<b>INNOLUX</b> 群創光電	<b>AV 產品終止生產通知</b> The End of AV Product Life Letter	保管單位 Storage	市場
		保存年限 Retention Period	3年

**Model name of phase out: AT050TN22 V.1**

**Issue date: 2013-1-16**

**EJ050NA-01G**

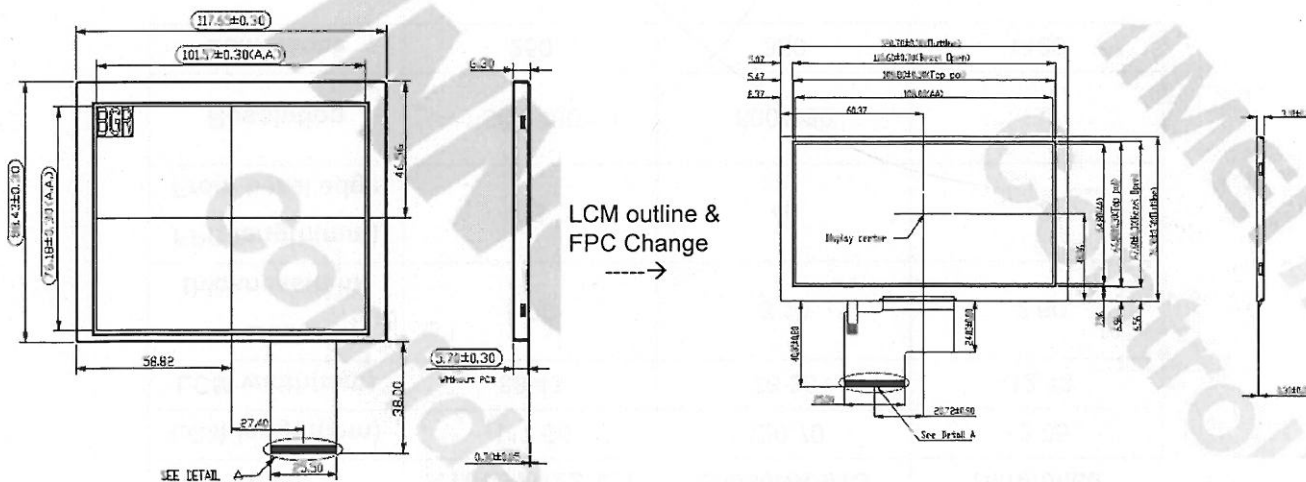
1.外觀差異 Appearance Difference  Yes  No

Item	AT050TN22 V.1	EJ050NA-01G	Difference
LCM length(mm)	117.65	120.70	+3.05
LCM width(mm)	88.43	76.30	-12.13
LCM thickness(mm)	5.70	3.10	-2.60
FPC length(mm) From bezel edge	38	40	+2
Resolution	640*480	800*480	
Luminance	250	350	+100
